Ms Gabrielle Allan  
Principal Planning Officer  
Energy Resource Assessment  
NSW Department of Planning and Environment

**Objection to modification 5 deals Angus Place Mine's consent (MP06\_0021) and modification 8 to Western Coal Services (SSD-5579)**

Figure indicates the 800 and 900 mining voids proposed to be dewatered are within 2km of EEC swamps (reference: Centennial Coal, Cocks River Swamp Review, July 2018, figure is in Appendix A, page 4).

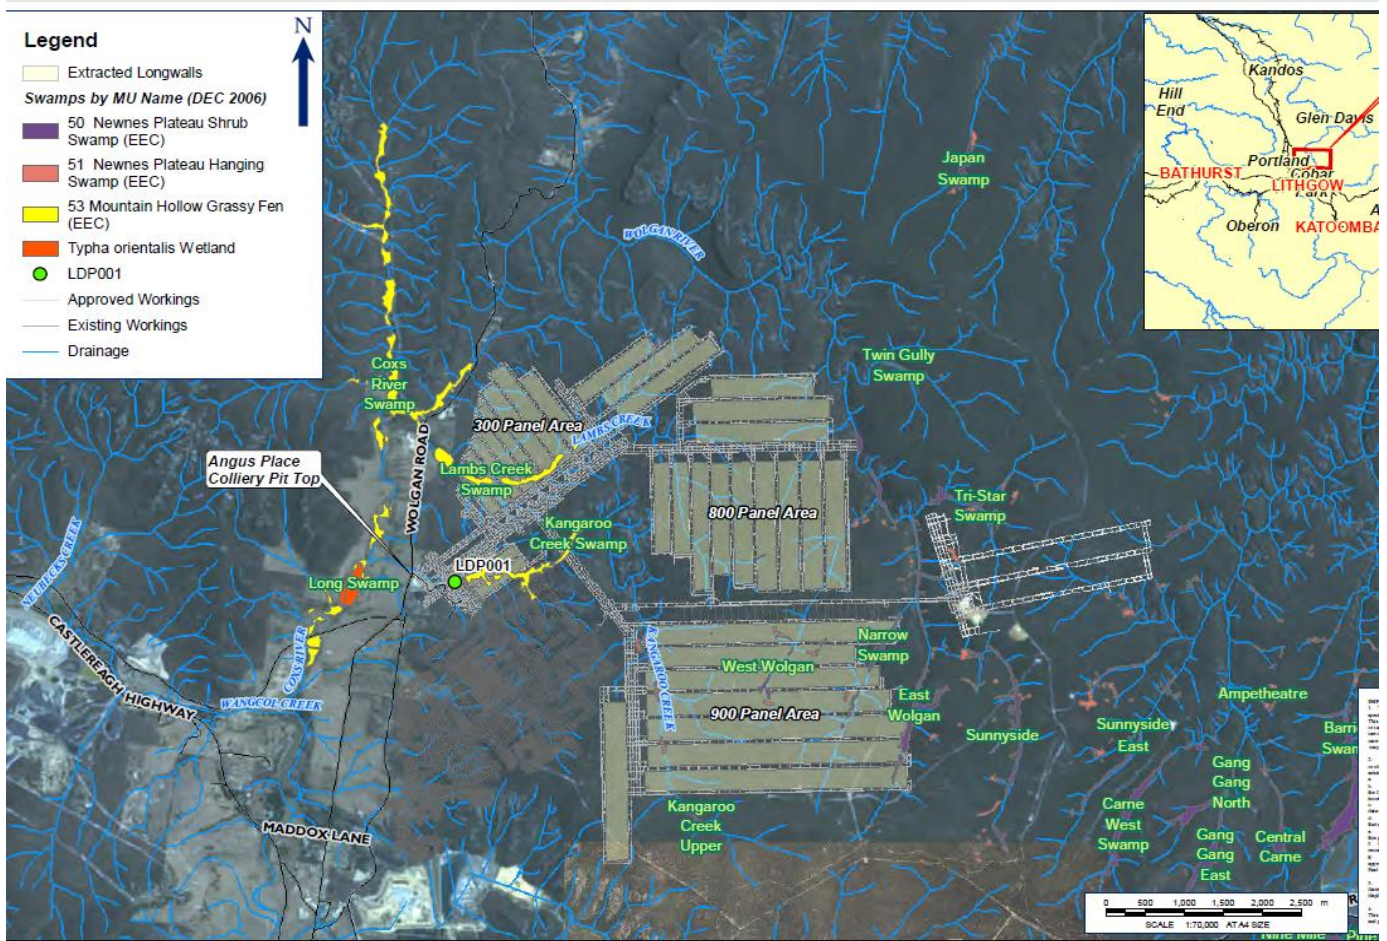
In its 2018 report Centennial Coal attempts to “pass off” observed sudden drops in groundwater in Coxs River swamps and loss of stream flows due to drought conditions and that such losses could not be associated with coal mine due to the presence of clay and shale aquicludes. These seemingly obvious explanations overlook a plausible explanation of sudden water loss from far-field dewatering impacts. These observed sudden losses of surface waters and near-surface groundwaters were probably associated with lineaments that connect the Coxs River and Kangaroo and Lambs Creeks with the 800 and 900 mine voids (see figure on following page 6).

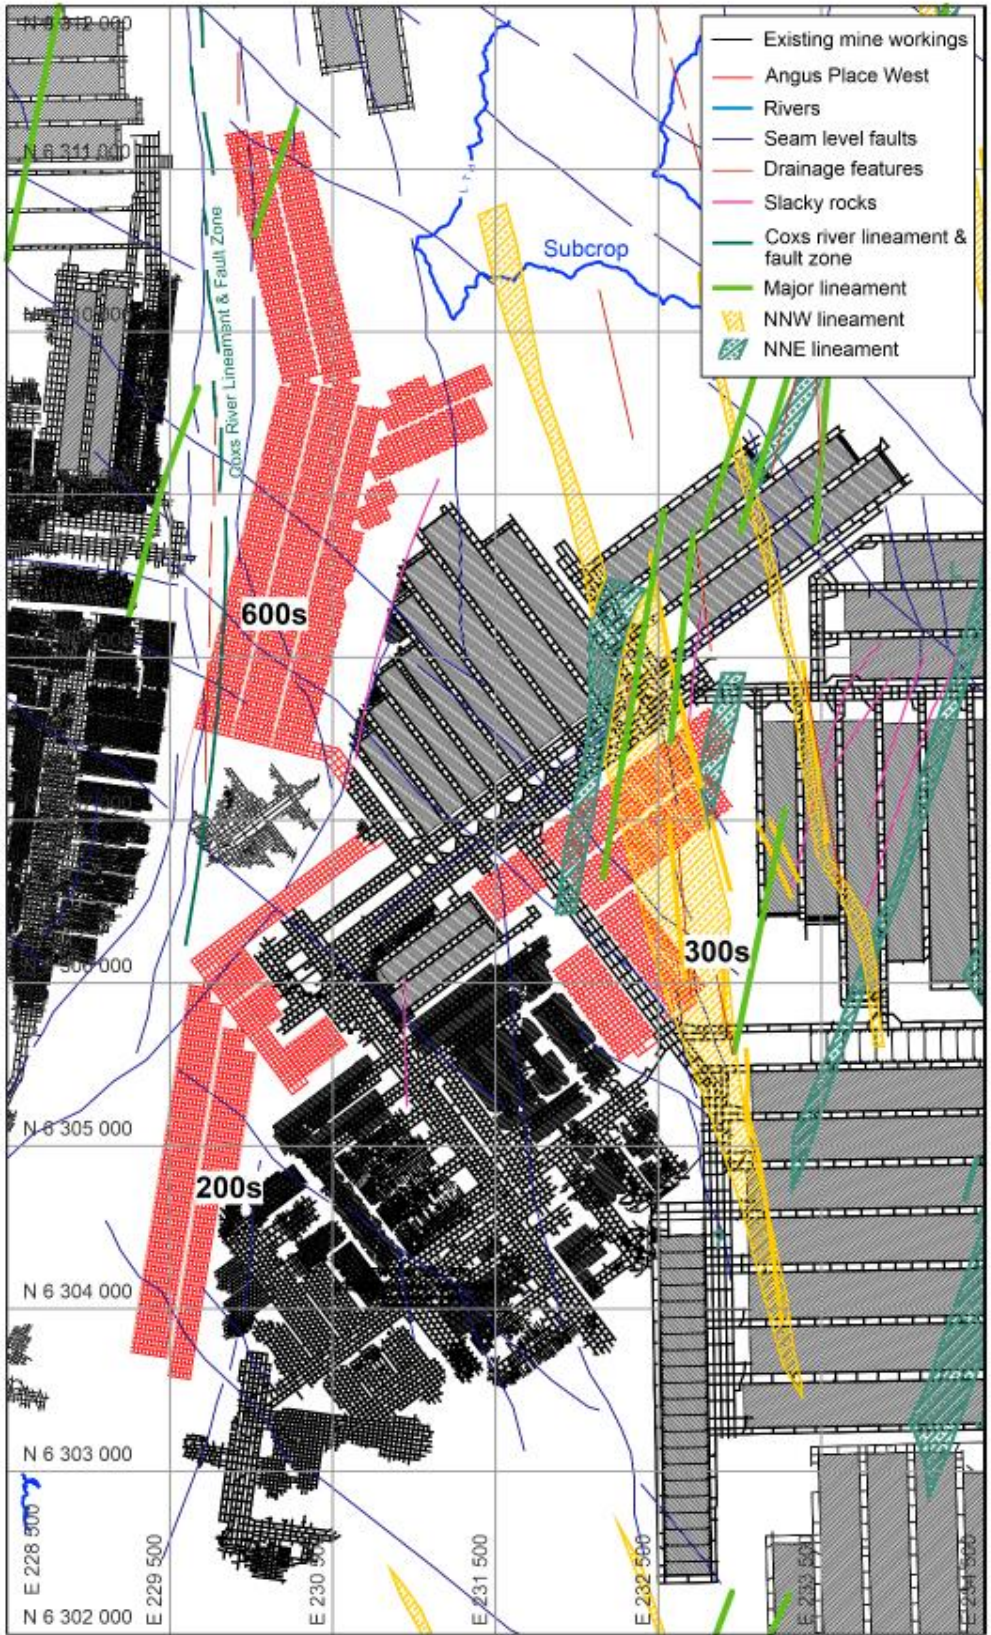
*This figure indicates that lineaments intersect Mine Areas 800 and 900 as well as the in the Angus Place West project area. Far-field drawdown of swamps and streams in the project area is likely, i.e. drawdown of Lambs and Kangaroo Creeks and swamps, as well as the Coxs River and its swamps.*

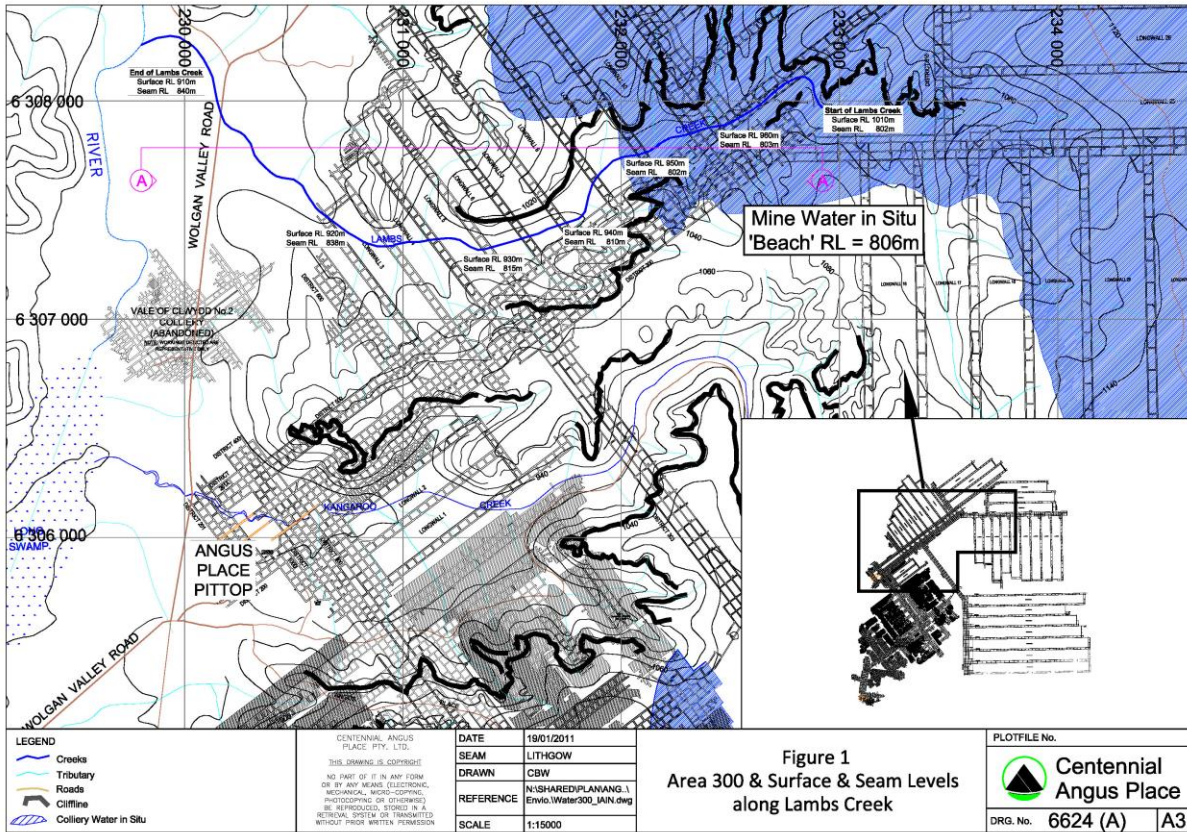
This Centennial Coal figure indicates how the Colliery water surface in blue at Area 300 relates with Area 800. Dewatering area 800 and 900 will also dewater Area 300. The depth to coal seam is less than 150m. The interaction between dewatering of these shallow mine workings and surface waters seem likely.
